**SITE PLAN REVIEW COMMITTEE  
MEETING AGENDA**

## **ITEM 1**

SP #437 670 N. Glebe Road (672 Flats)  
(RPC# 13-018-009; -012; -013; -014; -016; -017)

### **AGENDA: Second Meeting—April 16, 2015**

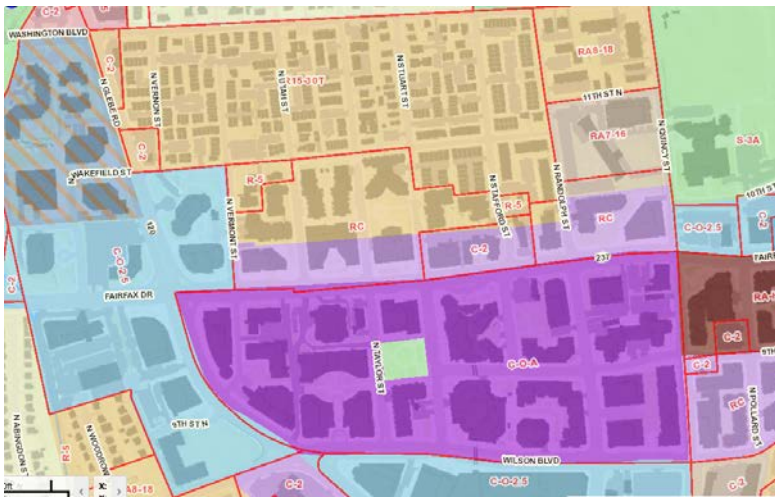
- Building frontage on Glebe Rd.
  - Massing – the proposed building provides a >400-foot building wall along the Glebe Road frontage with no relief provided by the current massing scheme. Should the building be broken up or provide other massing elements such as recesses and projections to provide relief along the long block frontage?

- Architecture – the proposed building provides a unified architectural style along the totality of the Glebe Road frontage with a strong central element. Should more differentiation/asymmetry and rhythm be provided in the architectural scheme to provide a more human-scale experience?
- Building entrances – only three (3) entries are provided along the Glebe Road frontage. Creation of an active frontage will require more entries.
- Building frontage on 7<sup>th</sup> Street – the 7<sup>th</sup> Street frontage is approximately 88 feet in length. Of this, the applicant proposes 37 feet of curb cuts for the loading access and the garage access. Therefore, slightly less than half the frontage consists of curb cuts. Will this disrupt pedestrian traffic travelling north on 7<sup>th</sup> Street?
